SUBJECT: CORPORATE AND STATION STAFF ORGANIZATIONAL STRUCTURE (TAC NO. 66115)

RE: PEACH BOTTOM ATOMIC POWER STATION, UNIT NOS. 2 AND 3

These amendments would modify Section 6 of the facility Technical Specifications to reflect (I) a new corporate and (II) a new plant staff organizational structure, (III) a revised composition of the Plant Operations Review Committee and (IV) several administrative changes.

FIGURE 6.2-1

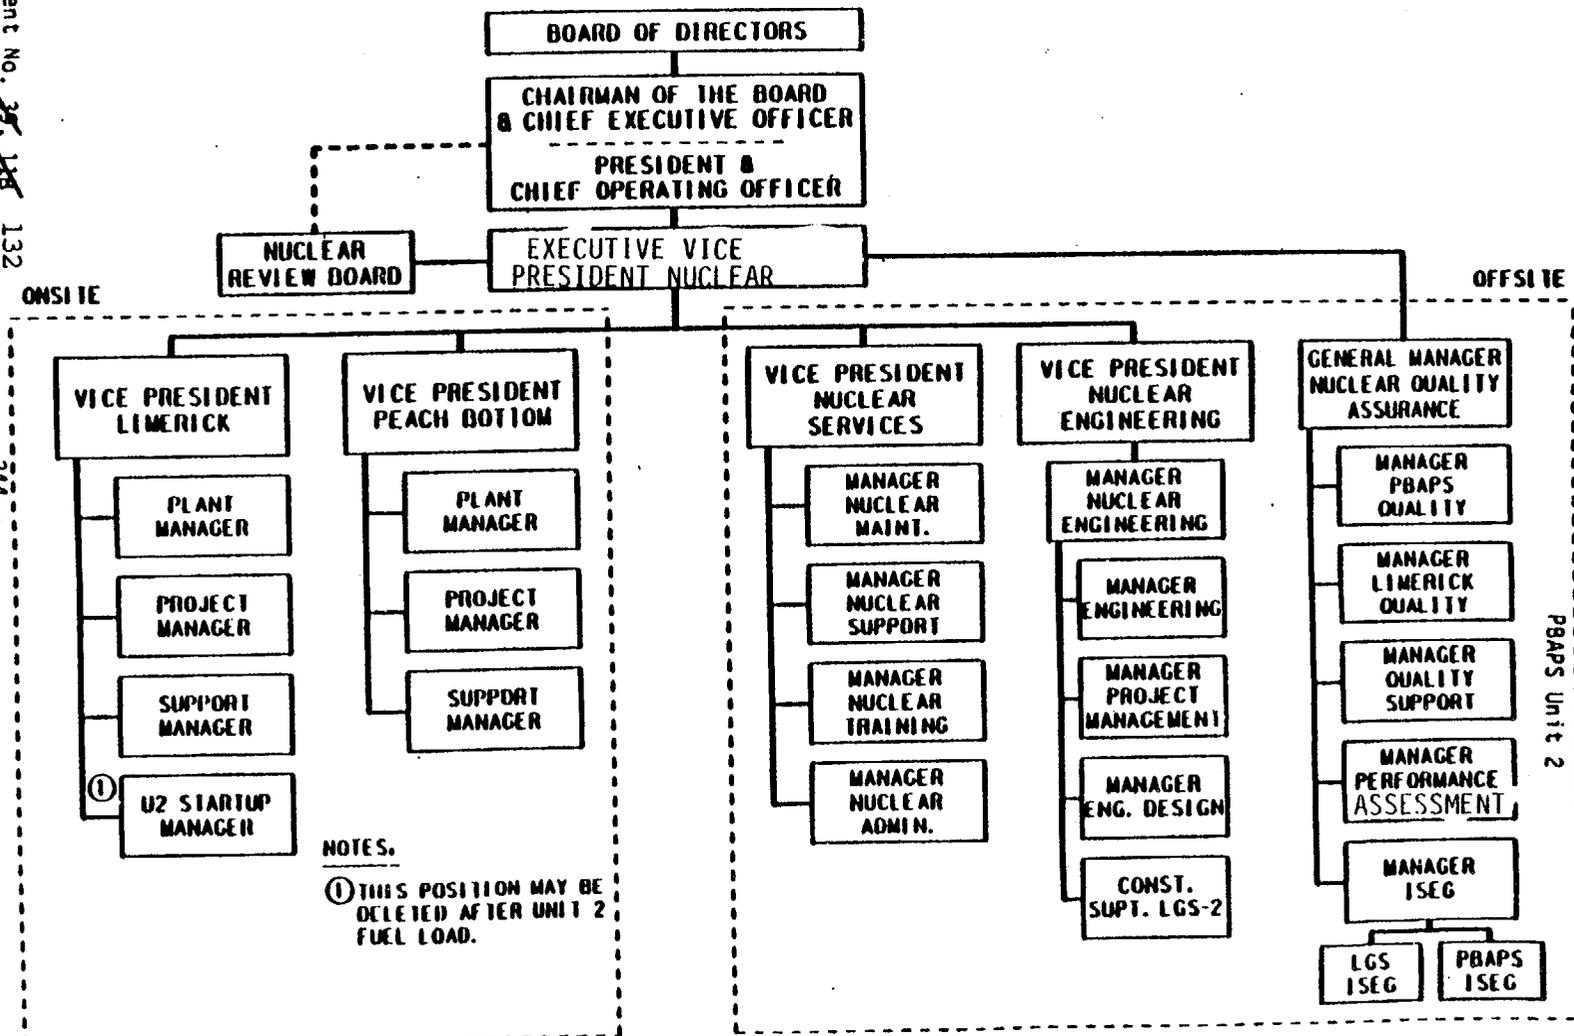
The offsite organization for facility management and technical support shall be as shown on Figure 6.2-1.

I. Offsite Management and Support Organization, Figure 6.2-1

President-Nuclear Power, Nuclear Production Manager, Superintendent-Nuclear Generation Division, Superintendent-Nuclear Services, and Manager-Nuclear Plant have been abolished and the functions under these positions have been reassigned within the new organization under the Executive Vice President-Nuclear. Revision I of the Plan for Restart included a change in the title of the senior nuclear executive to Executive Vice President-Nuclear. The new organization is shown in revised Technical Specification (TS) Figure 6.2-1. Reporting to the Executive Vice President-Nuclear are the Senior Vice President-Nuclear, Vice President-Nuclear Services, Vice President-Nuclear Engineering, General Manager-Nuclear Quality Assurance, Vice President-Limerick and Vice President-Peach Bottom. In addition, the Nuclear Review Board (NRB) reports directly to the Executive Vice President-Nuclear.

The new office of Vice President-Nuclear Services has responsibility for nuclear service activities that support the station. Reporting to the Vice President-Nuclear Services are the Manager-Nuclear Support, Manager-Nuclear Maintenance, Manager-Nuclear Training, and Manager-Nuclear Administration. The Manager-Nuclear Support is responsible for licensing, fuel management, radiation protection, radioactive waste management, nuclear plant chemistry, emergency preparedness, nuclear plant security and the Operating Experience Assessment Program.

We have reviewed the requested changes and found them acceptable as they meet the acceptance criteria of the appropriate parts of Section 13.1.1 of NUREG-0800, the Standard Review Plan.

## ORGANIZATION FOR CONDUCT OF PLANT OPERATIONS PEACH BOTTOM ATOMIC POWER STATION

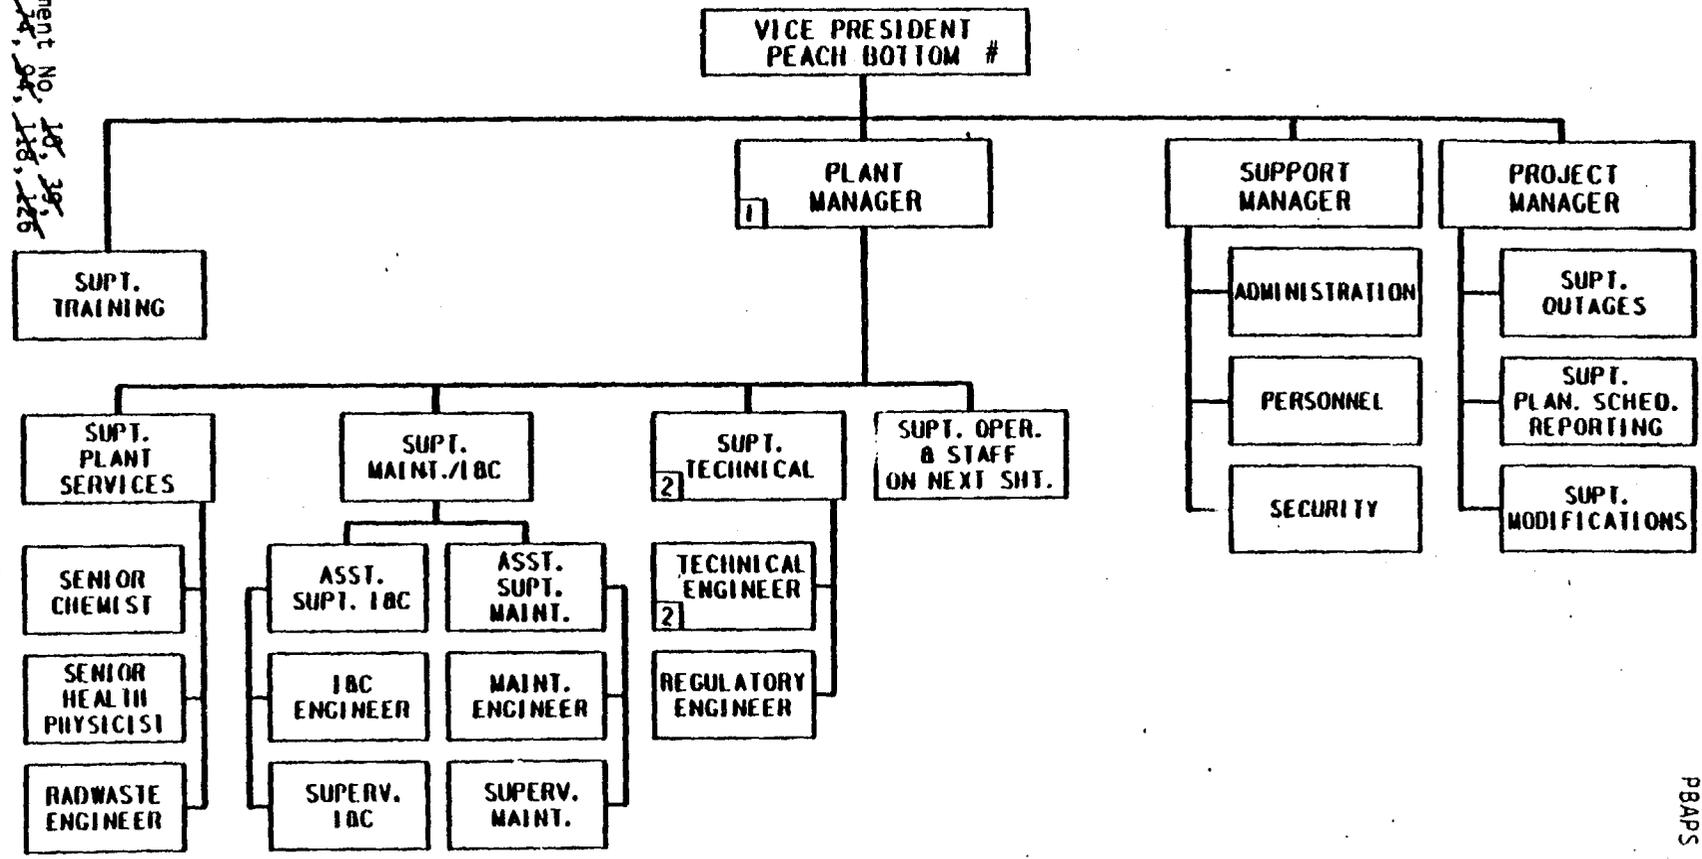
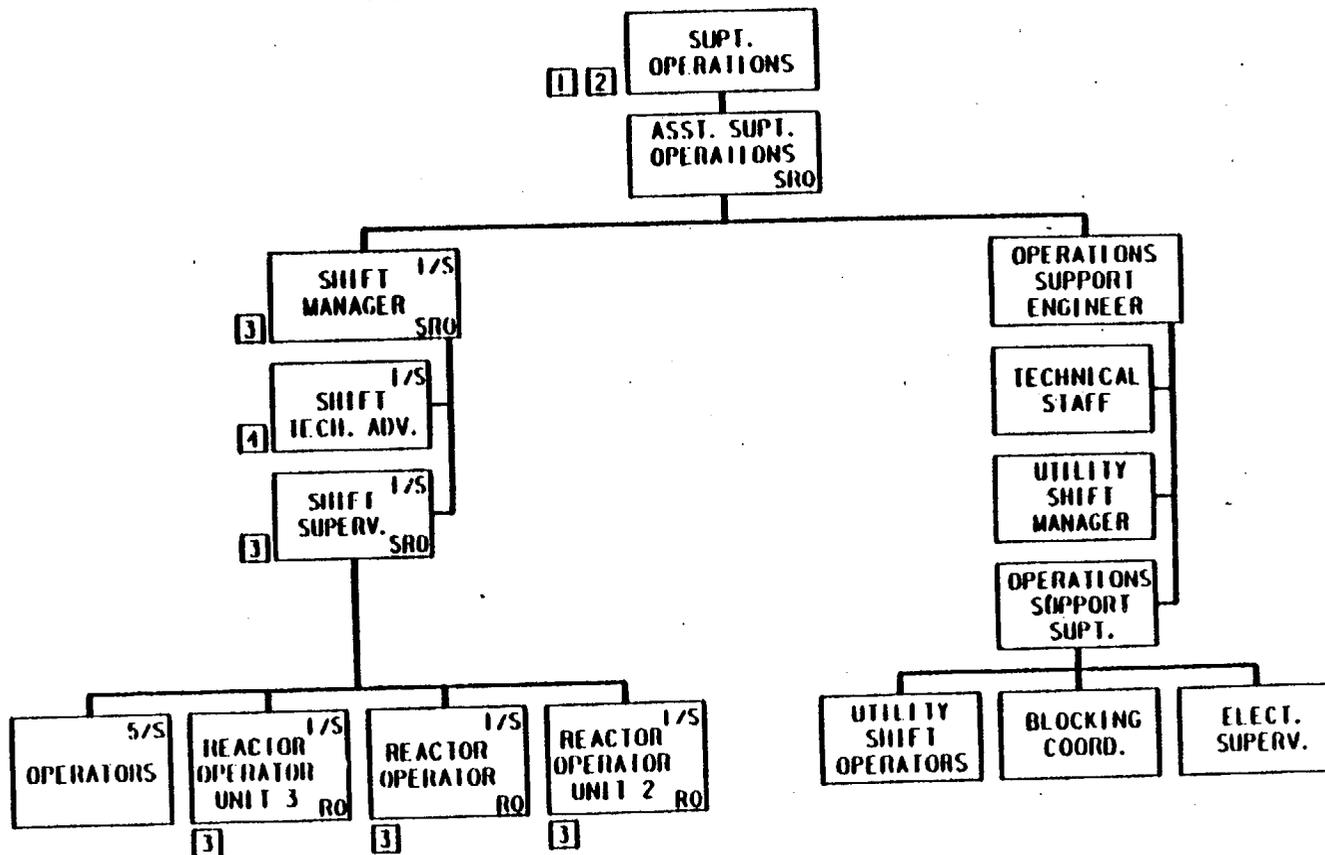
The facility organization shall be as shown on Figure 6.2-2 and:

## II. Onsite Management Organization, TS Figure 6.2-2

PECo has established a new office of Vice President-Peach Bottom Atomic Power Station which will have overall control for the conduct of activities of all organizations at the Peach Bottom site. The Vice President-Peach Bottom Atomic Power Station will be located at the Peach Bottom site. PECO has reassigned current functions and added new functions under a Plant Manager, Support Manager, Project Manager and Superintendent-Training, who all report directly to the Vice President-Peach Bottom. The licensee also proposed to delete the designation of the Nuclear Generation Division (NGD) Superintendent as being responsible for the overall fire protection program. This designation was made in amendment number 39 and the licensee does not provide sufficient specificity in its application regarding how this responsibility will otherwise be met. Therefore this request is denied as stated in the Federal Register (52 FR 48593-48597) on December 23, 1987. Designation of this responsibility will remain with the VP-PBAPS, which is the level of responsibility approximately equal to that of the NGD Superintendent in this regard.

The Plant Manager will be responsible for operating the plant safely, reliably, and efficiently in accordance with all applicable requirements. Reporting to the Plant Manager are the Superintendent Plant Services, Superintendent-Maintenance/Instrumentation and Controls, Superintendent Technical, and Superintendent Operations.

FIGURE 6-2-1

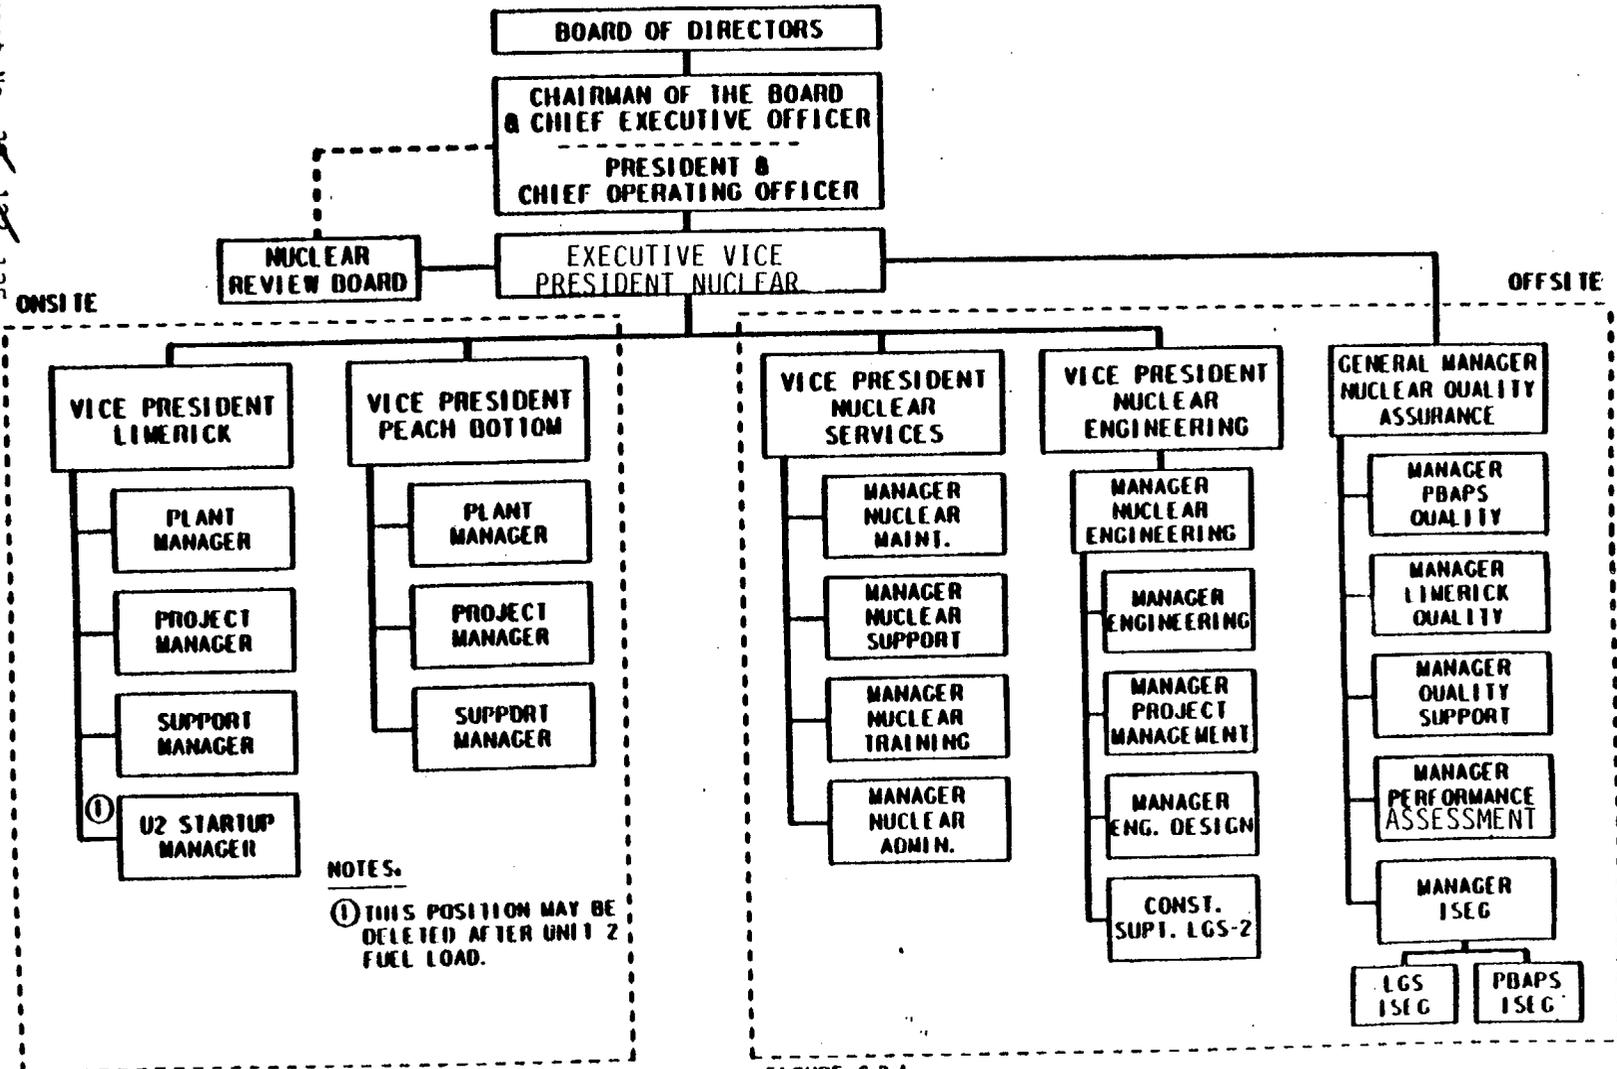
The offsite organization for facility management and technical support shall be as shown on Figure 6.2-1.

### ORGANIZATION FOR CONDUCT OF PLANT OPERATIONS PEACH BOTTOM ATOMIC POWER STATION

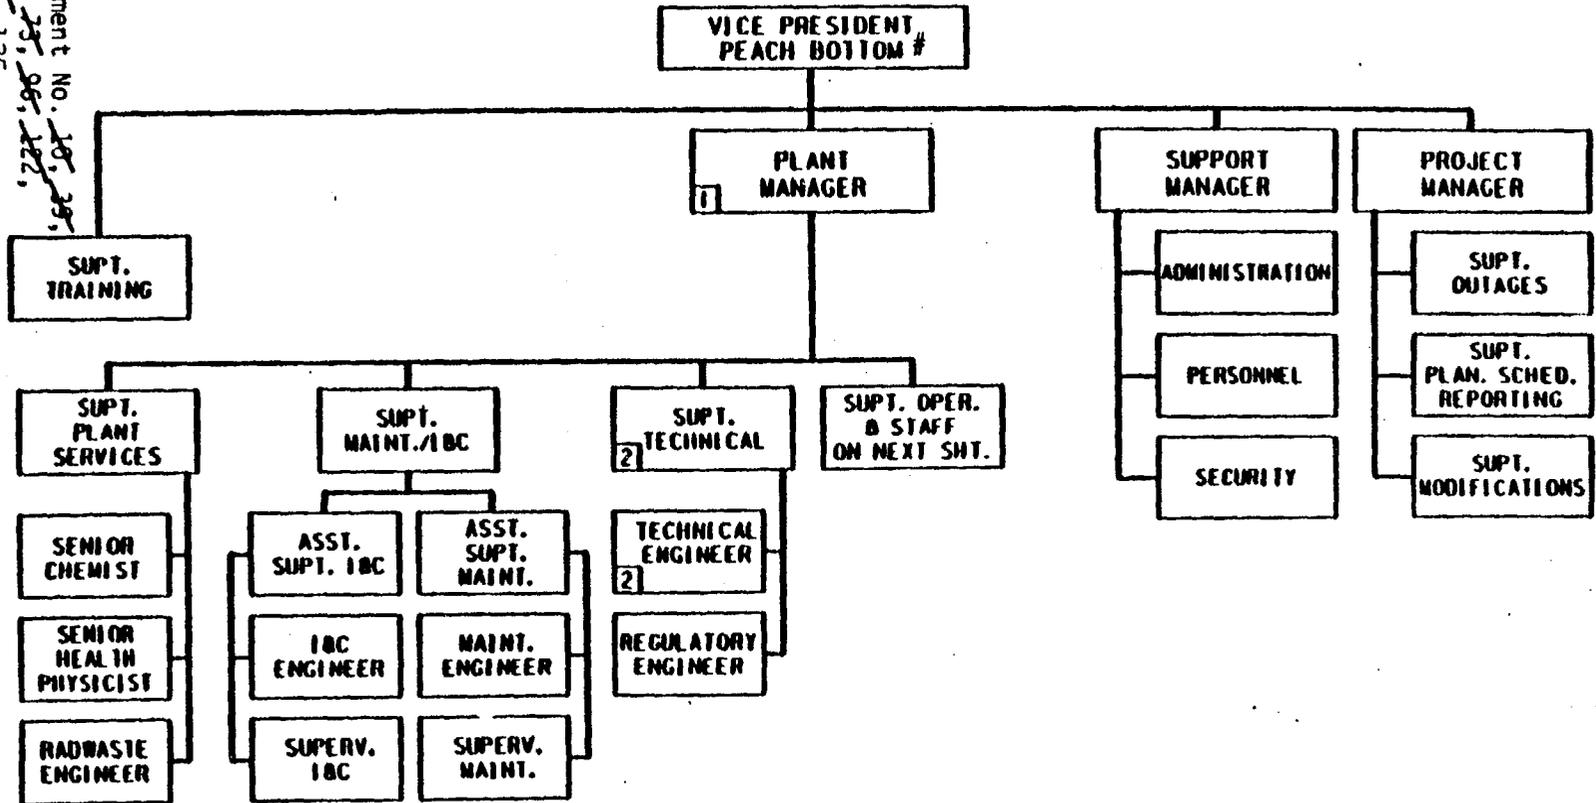
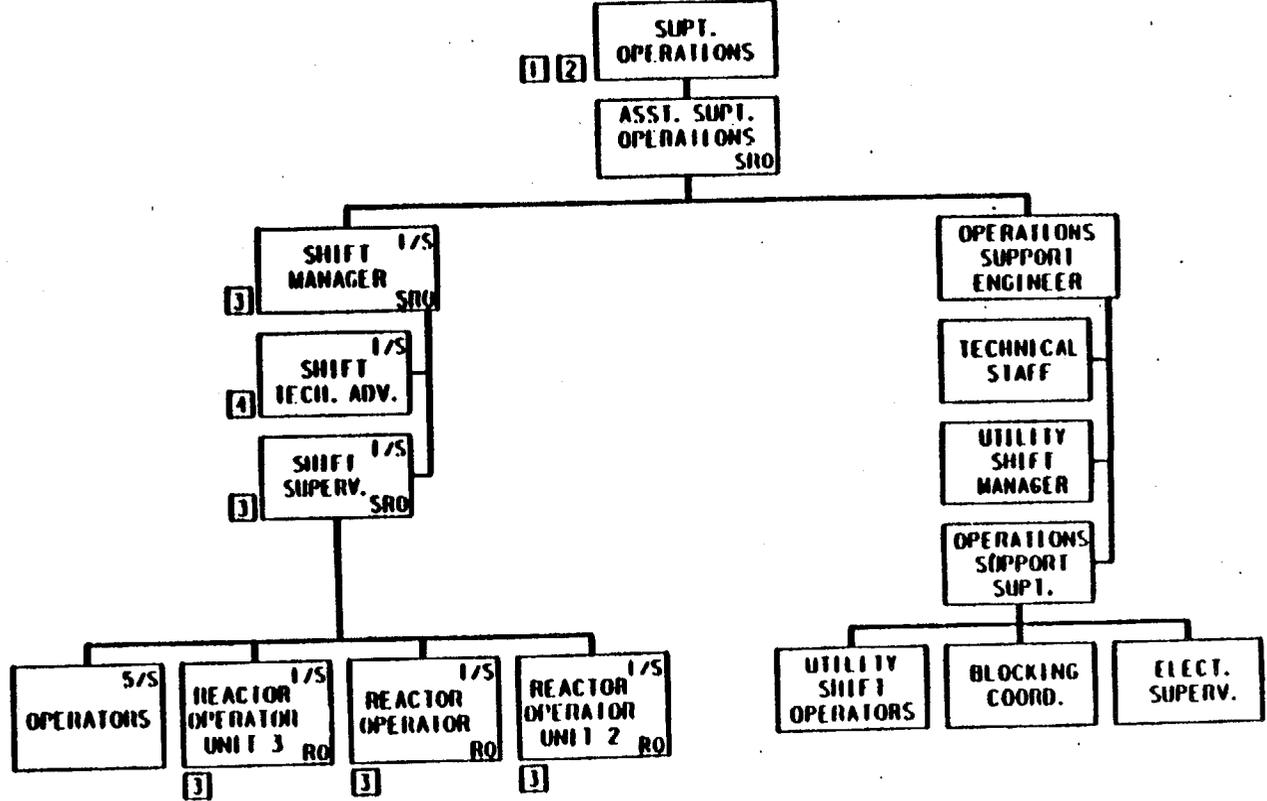
The facility organization shall be as shown on Figure 6.2-2 and:

The Superintendent-Operations will be responsible for management oversight of shift operations. Reporting directly to the Superintendent-Operations is an Assistant Superintendent-Operations. Reporting to the Assistant Superintendent-Operations are the Shift Managers and an Operations Support Engineer. The Shift Managers will manage the operations of the plant on their assigned shifts. The Operations Support Engineer provides support to the operating shifts. Reporting to the Operations Support Engineer will be a Technical Staff, Utility Shift Manager and Operations Support Superintendent. The licensee did not propose any change in the interim relief granted by amendments 126 and 129 regarding the holding of an SRO license by either the Plant Manager or the Superintendent-Operations. Therefore, the relief provided by those amendments continues in effect and is shown on Figure 6.2-2.
